Product Change Notification

REVISED November 13, 2018

Bourns® Model SRF0703, SRF1260 & SRF1280 Series Dual-Winding Shielded Power Inductors

Terminal 1 Identification Marker Added

Current		Revised	
Recommended Layout	2 \leftarrow 1 3 \leftarrow 4 DUAL INDUCTOR MODE	2 \int 1 3 \int 4 SERIES MODE	1 2 2 4 3 3 DUAL INDUCTOR MODE	1 2 4 3 SERIES MODE

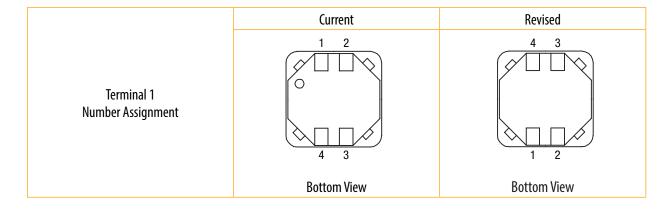
On the data sheet, the terminal number assignment (shown below) will be rearranged to align with the Terminal 1 marker. These numbers are not marked on the actual part.

The mounting base mold injection mark, which appears as a cycle on the bottom view of the drawing, will be removed from data sheet.
